| <b>PROPERTY INFORMATION</b> | <b>Fieldcrest Acres Ph1 Preliminary PD</b> |

## Variance Submittal Letter and Supporting Documents

**RE: Fieldcrest Acres- Phase 1  
Fieldcrest Road  
Variance Request for Street Connections**

**ROAD A: Chimney View Loop**

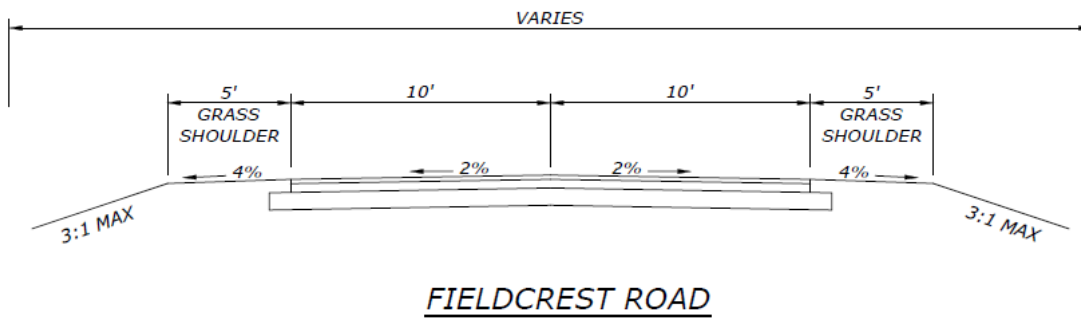
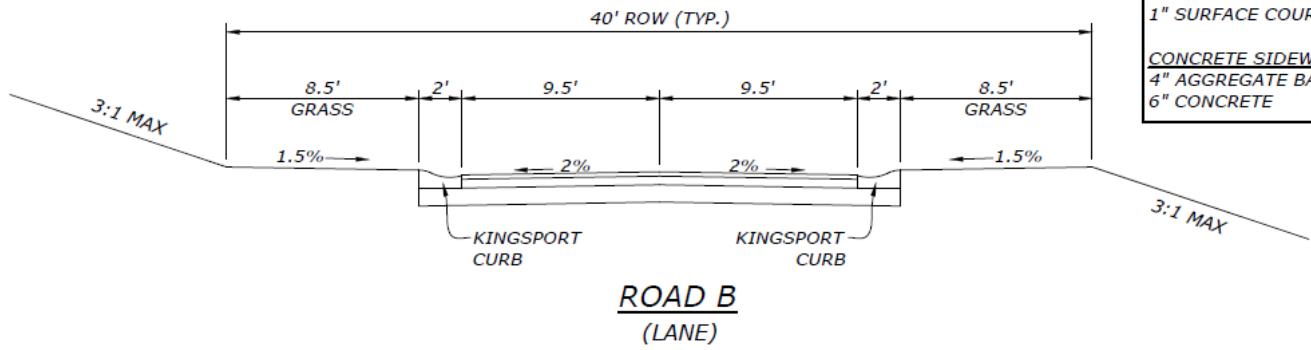
We are proposing a taper section from the Beginning of Construction (Sta. 11+51.37) to Sta. 12+80. This section of roadway will transition between the existing Fieldcrest Road width of ~20' to the proposed "Road A" width of 25'. Due to the lack of an established roadside ditch along Fieldcrest Road, we are proposing that no Kingsport curb or sidewalk be installed in this section. This will allow runoff from this section of roadway to remain in more of a sheet flow condition and not create any areas of concentrated flow.

We are proposing the section of roadway labeled as "Fieldcrest West" be 20' wide asphalt with 5' grass shoulders. This would match the existing width of Fieldcrest Road, and the utilization of grass shoulders would more closely match the current condition of Fieldcrest Road which does not have an established roadside ditch. By not installing curbs in this section, runoff from this section of roadway can remain in more of a sheet flow condition and not create any areas of concentrated flow.

Staff recommends granting preliminary approval along with the accompanying Chimney View Loop variances of no curb, gutter, or sidewalk for the first 130 feet of Chimney View Loop and no curb, gutter, or sidewalk and the 5' street width decrease to match exiting conditions for the Fieldcrest West connection to Chimney View Loop. It is staff's opinion that the proposal is an appropriate solution for addressing the transition from the existing Fieldcrest road to the proposed new local city street. The variances have been reviewed by and are also supported by the Kingsport Engineering Division as well as Kingsport Water Services.

Expanded View of Area Impacted by Variances

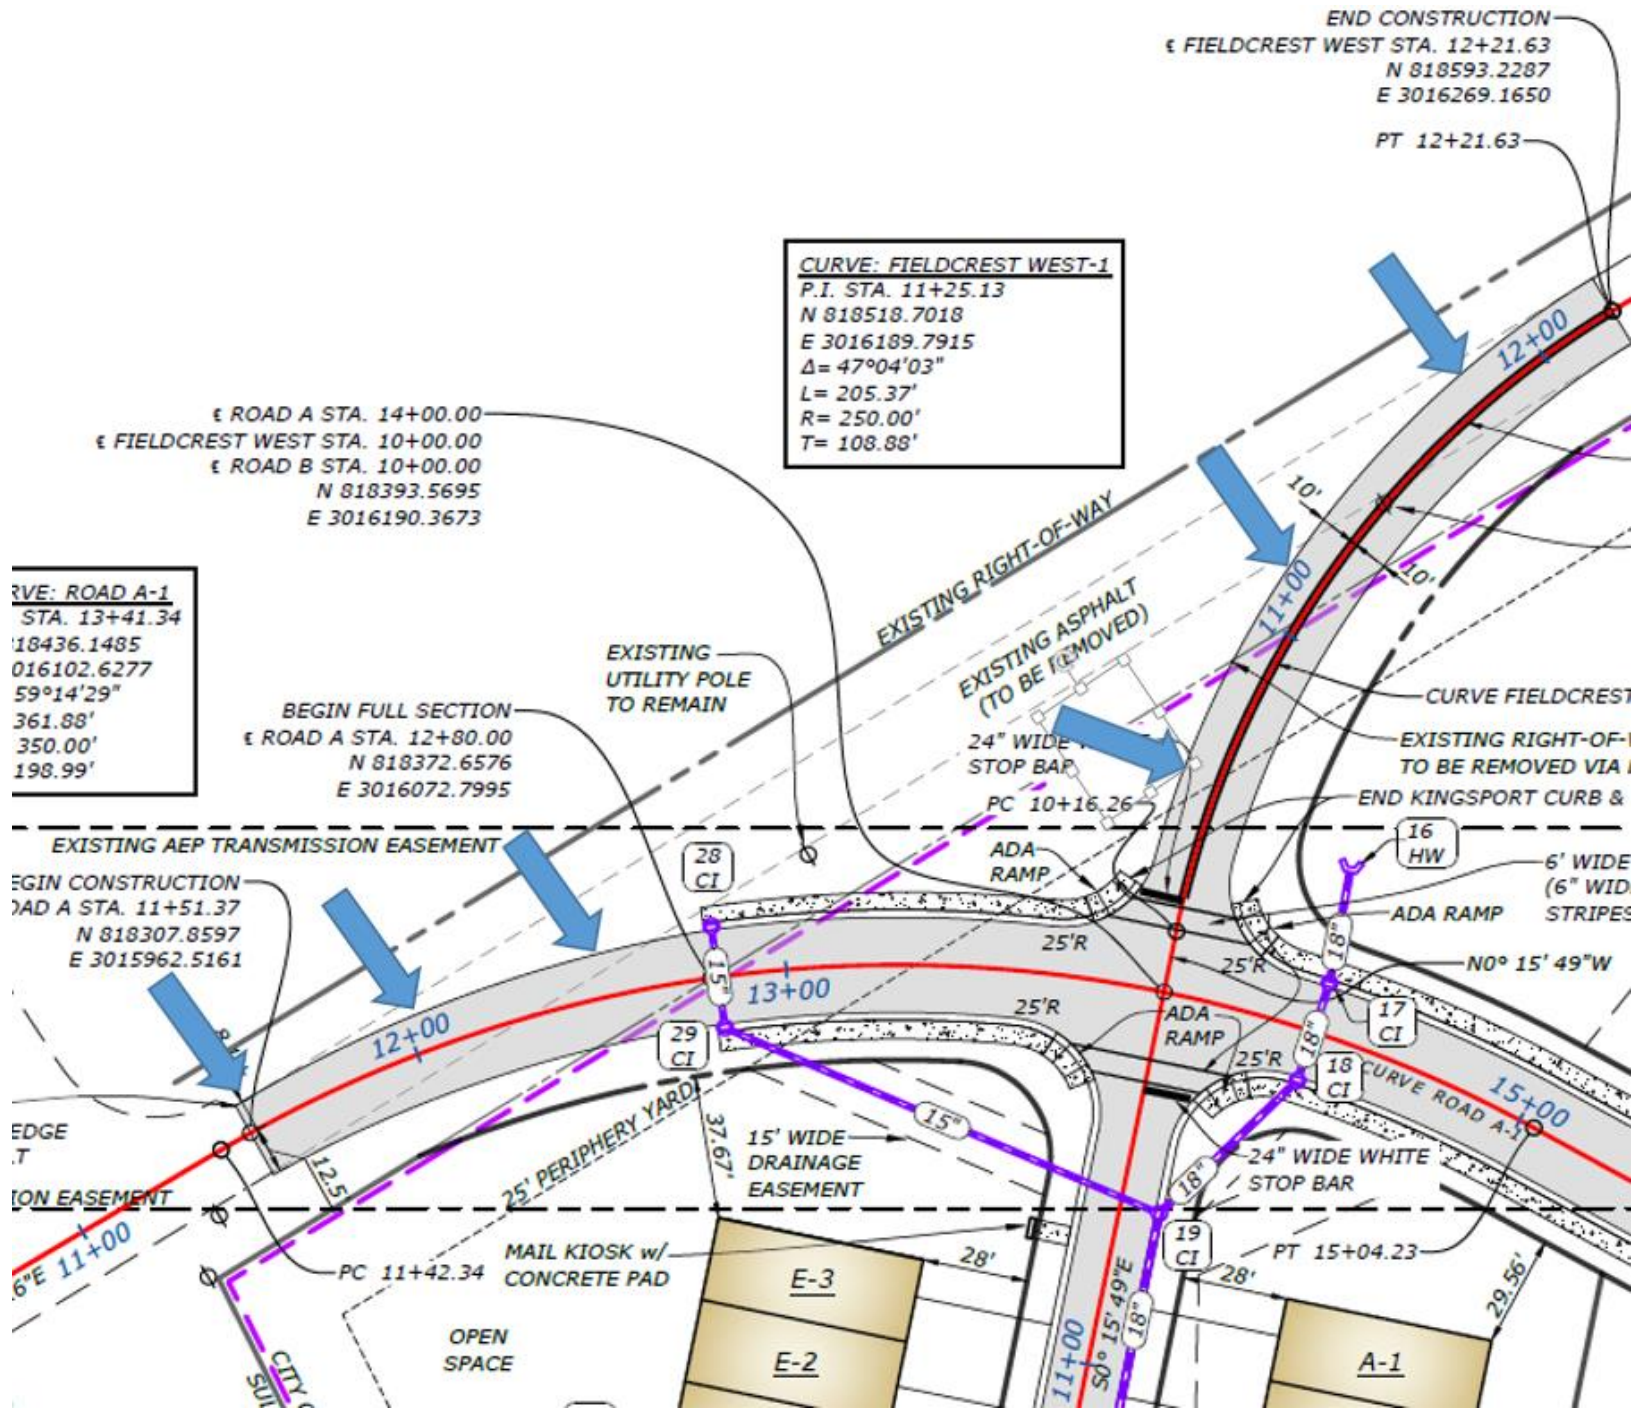
The applicant has submitted an accompanying variance request to address the transition from the existing Fieldcrest Road to what is currently named Chimney View Loop. The variance for the connection of Chimney View Loop to Fieldcrest Road is proposed to be tapered from 20’ to the standard 25’ for a local street. **The applicant desires to not construct curb or sidewalk for the first approximate 130’ of this section** due to the lack of an existing ditch to channel the associated water runoff. A second variance for the connection of Fieldcrest West to Chimney View Loop is proposed to be an extension of the existing 20’ Fieldcrest Road with 5’ grass shoulders. **The variance amounts to 5’ of pavement width, no curb, and no sidewalks which impacts the first 200’ of the connection off “Fieldcrest West.”** The rationale is similar to the first variance request in that there is no established ditch along Fieldcrest Road and granted variances will not concentrate water runoff. Outside the transition area described above there are no other needed variances.
